DESIGN ADVISORY BOARD Tuesday March 27th, 2018 at 3:00 PM Conference Room 12, City Hall, Burlington, VT Agenda

MEMORANDUM

To: The Design Advisory Board
From: Mary O'Neil, AICP, Principal Planner
RE: ZP18-0757CA; 131 Lakeview Terrace
Date: March 27, 2018

Request: Addition and renovation to historic single family home.

SHEET NO: **A-201**
© 2018 Freeman French Freeman Inc.

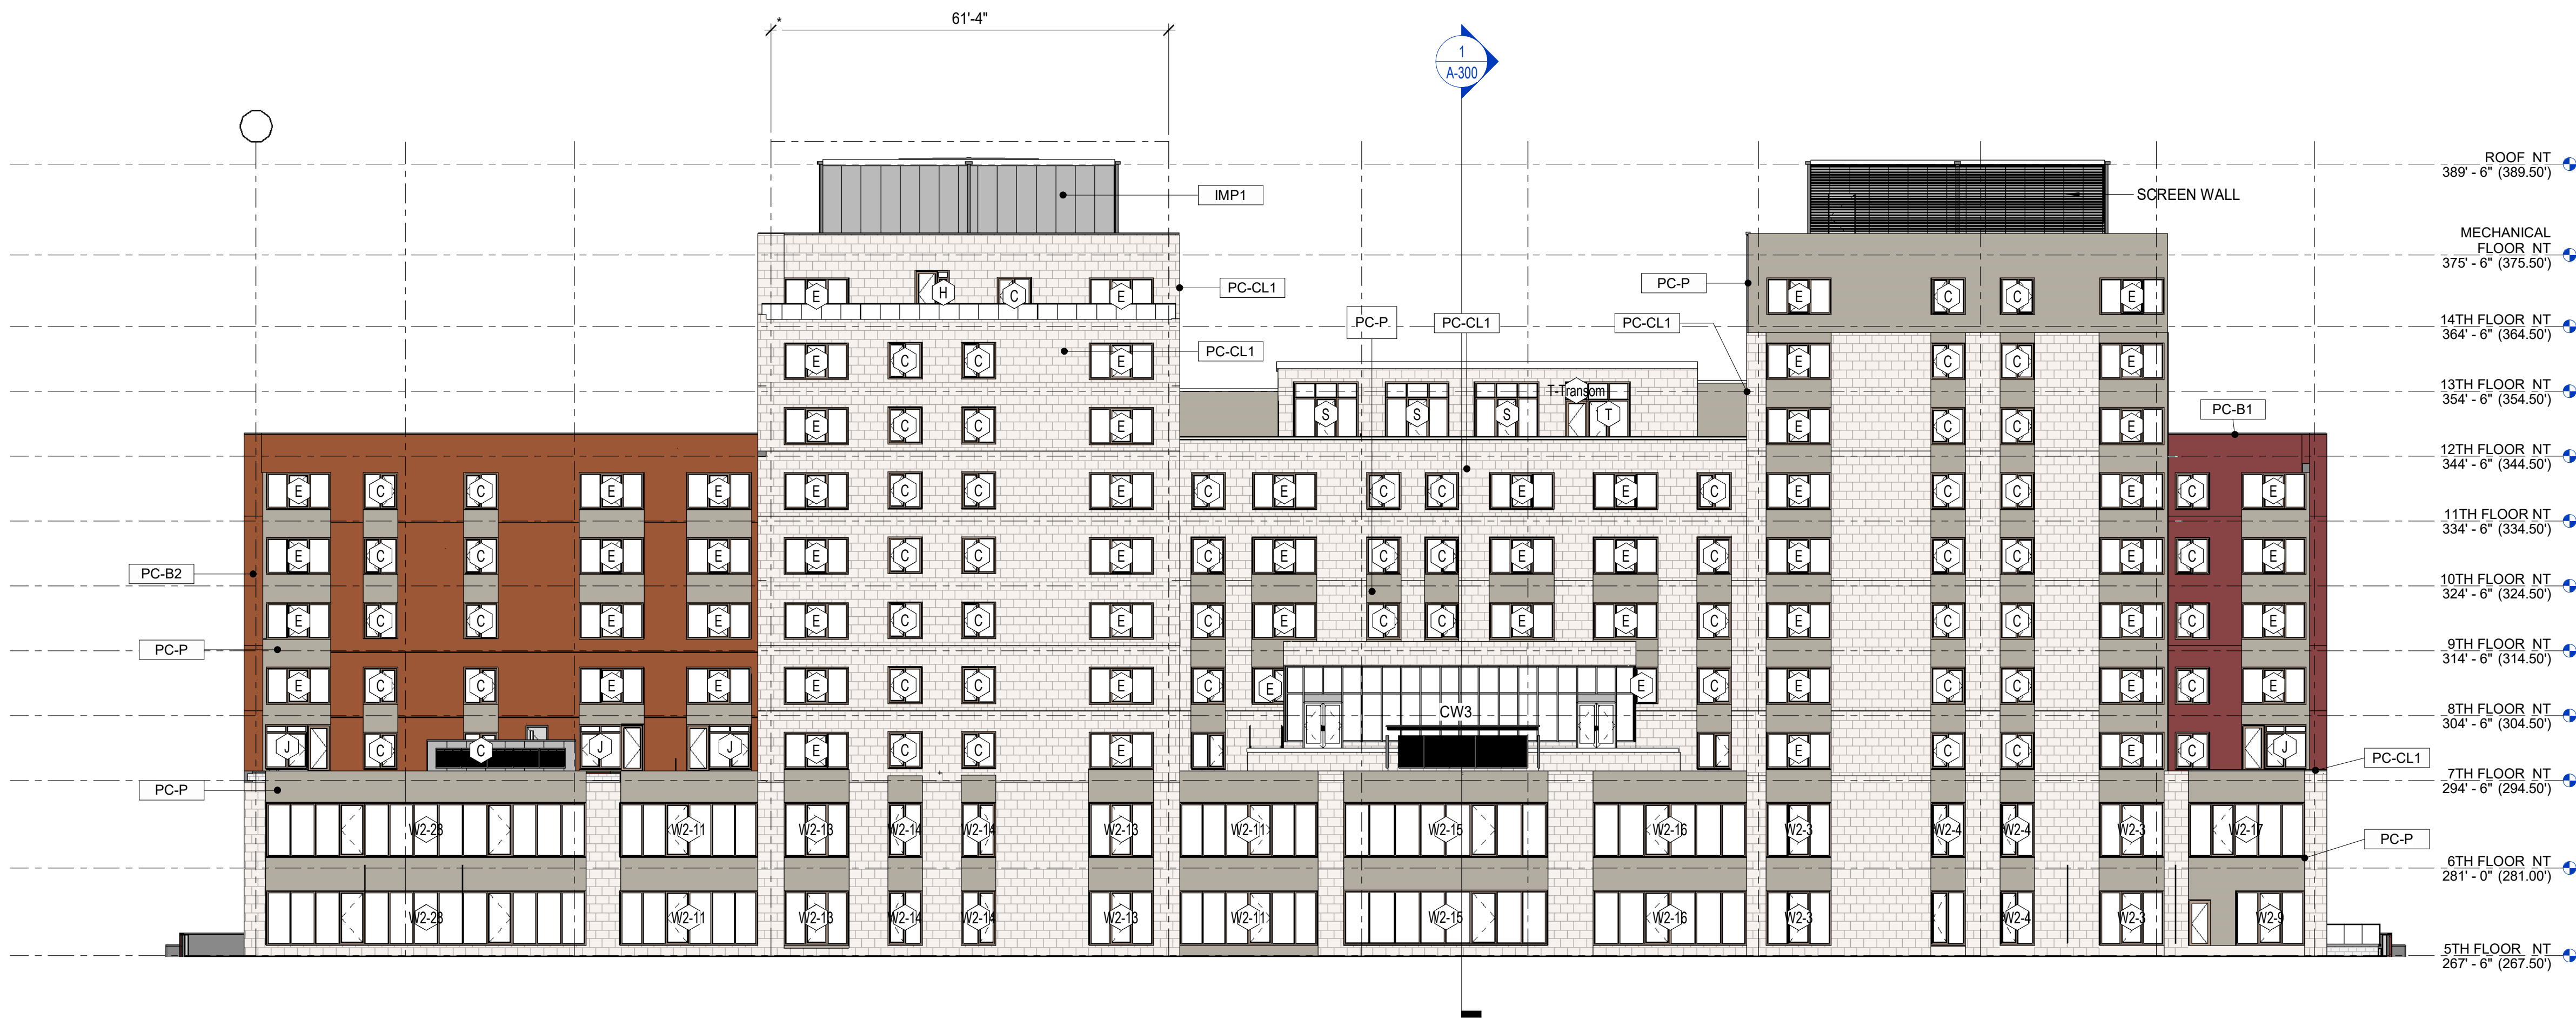
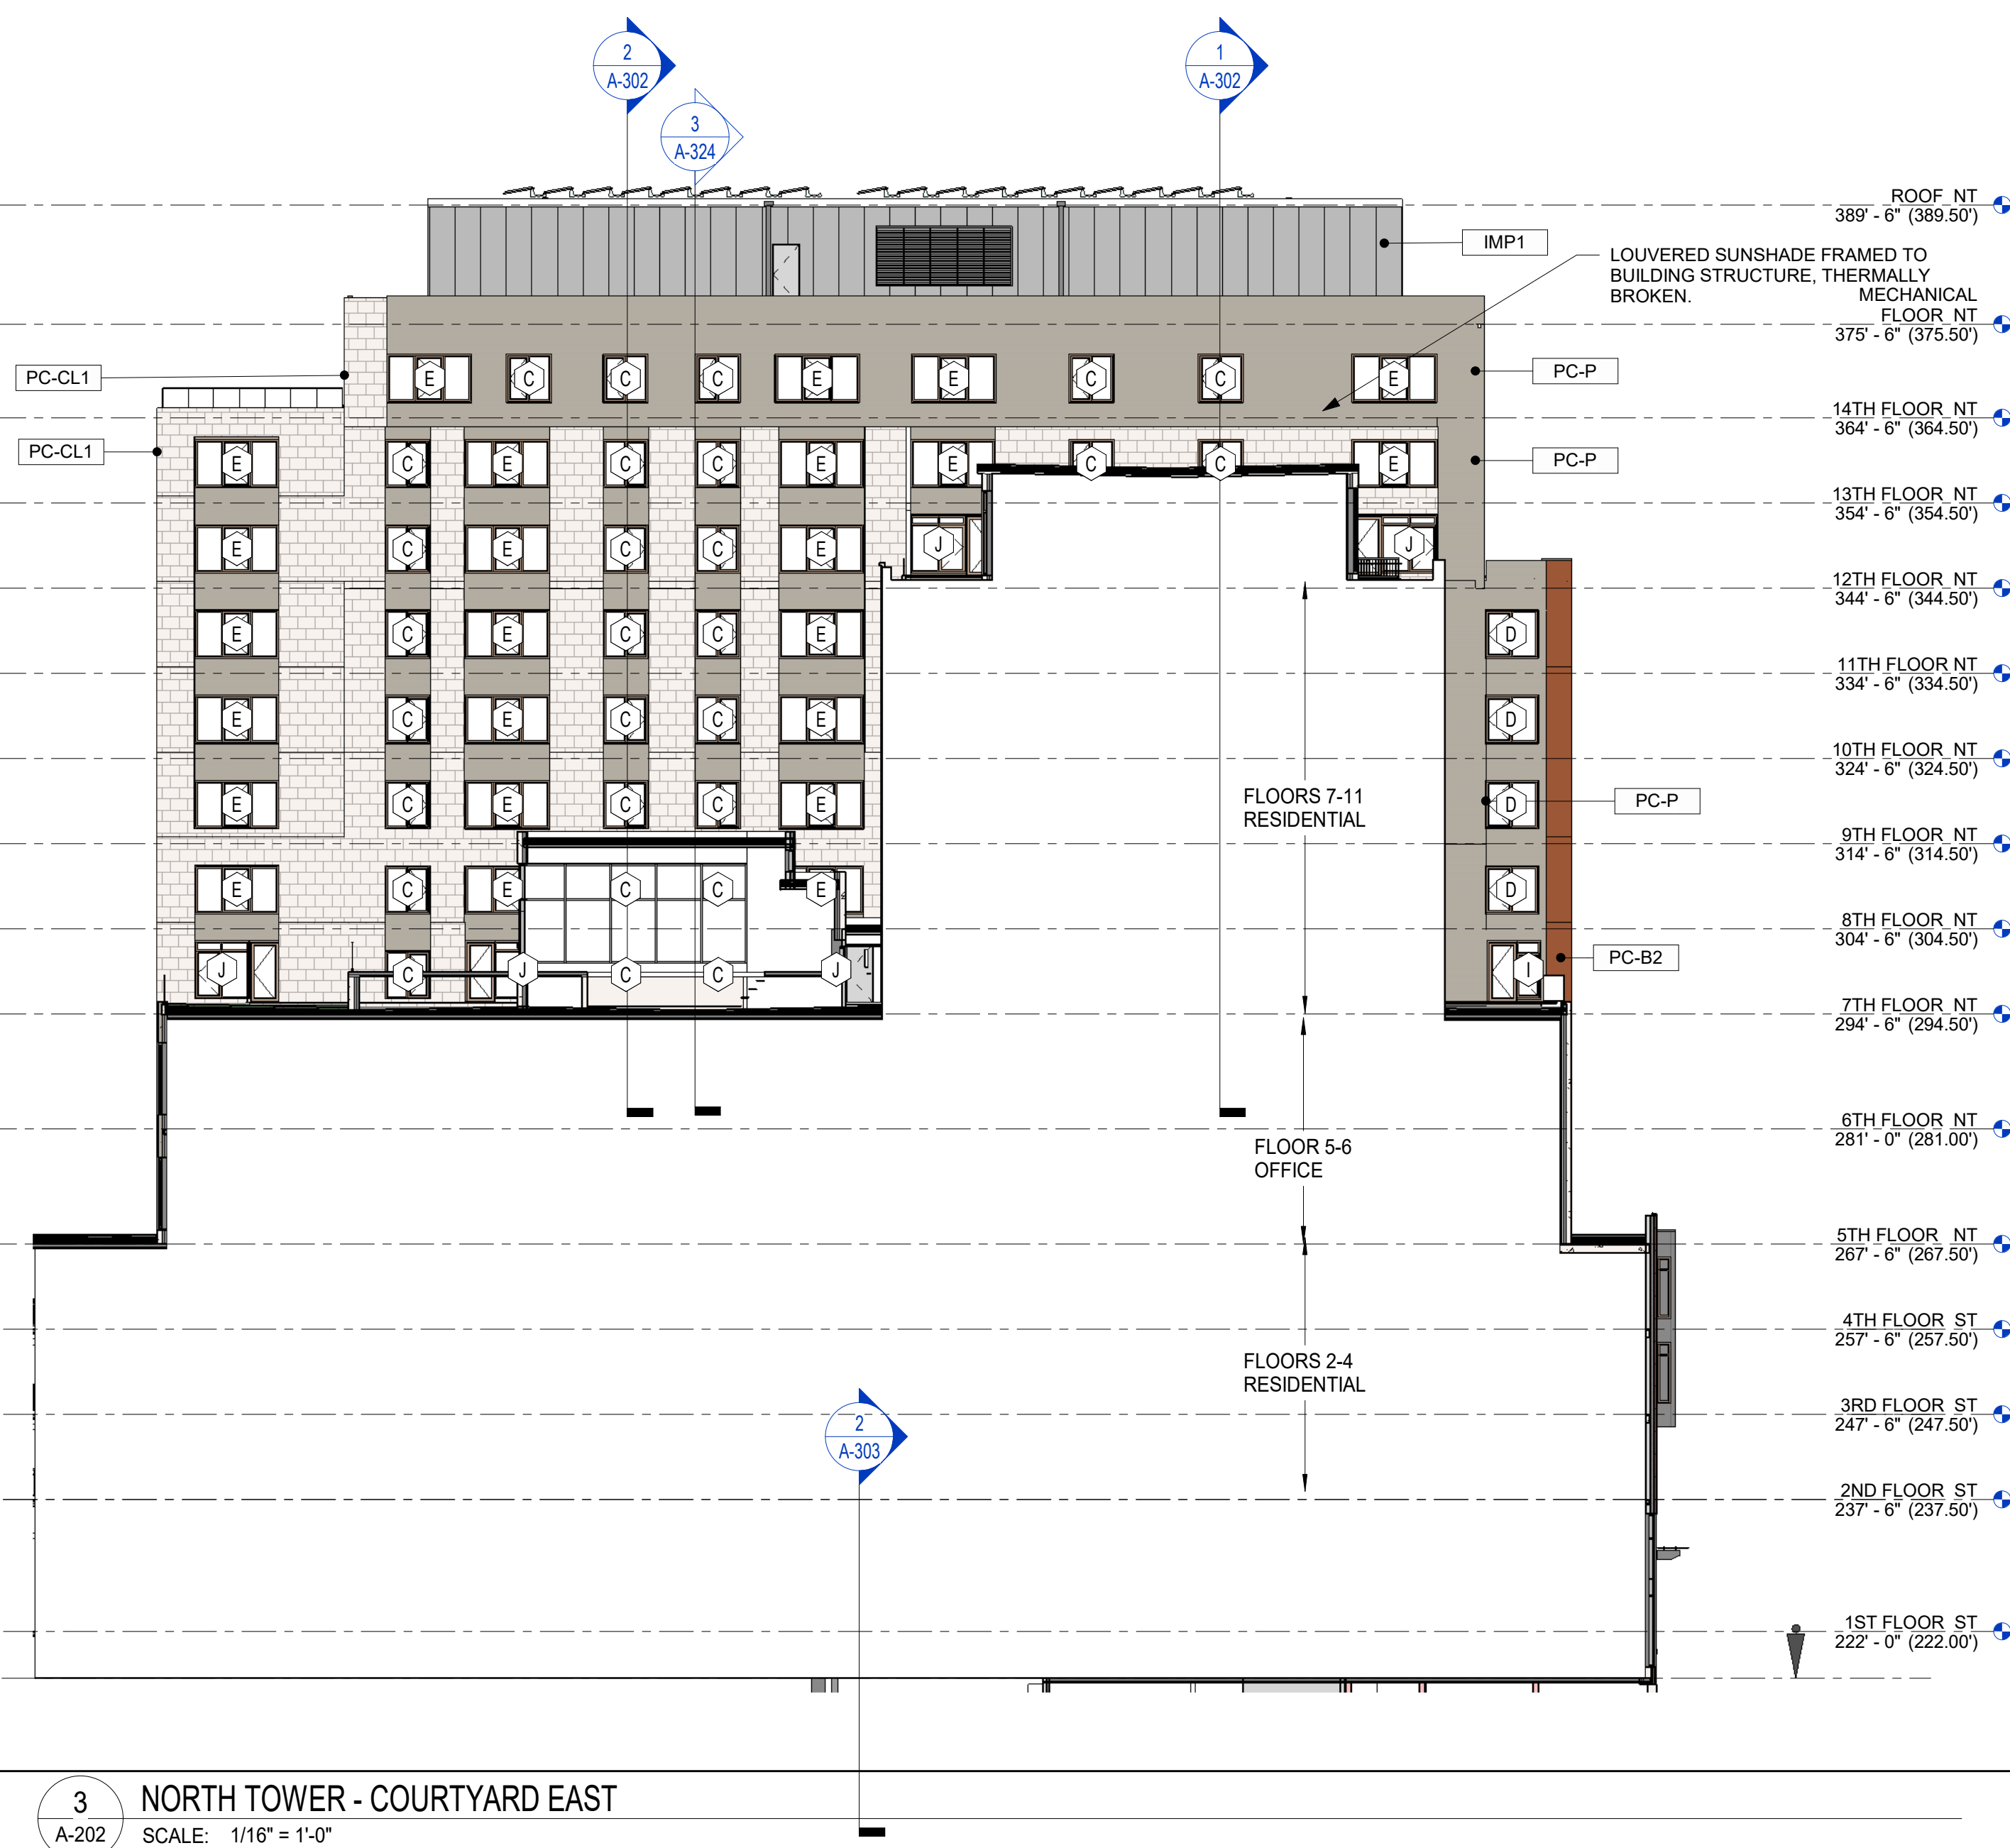
The pool/deck feature on the 7th floor will not be visible from any of the streetfront elevations (see Plans A200-A201.) The fitness center at the 12th floor will be apparent only from the north (Cherry Street) façade as a small building volume that is largely unapparent from street view (see lower illustration at A-202, sight lines noted.)
